X 91.132-26

## **MODELS** 40/45

## CRANKSHAFT SEAT COMPL.

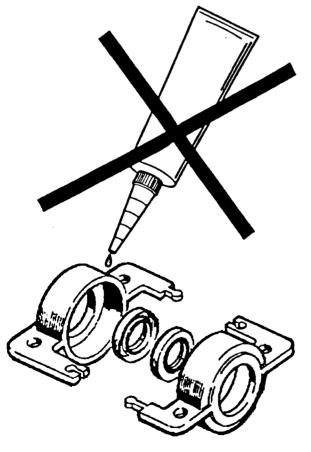
We have introduced a new crankshaft seat compl.

The new crankshaft seat has a sealing at the contact surfaces towards the crankcase resp. the cylinder. This means a simplification when servicing because there is no need for any sealing compound.

New Ref. No. 506 05 65-02

The change is introduced from serialnumber: 40- 1050001

45-1061401
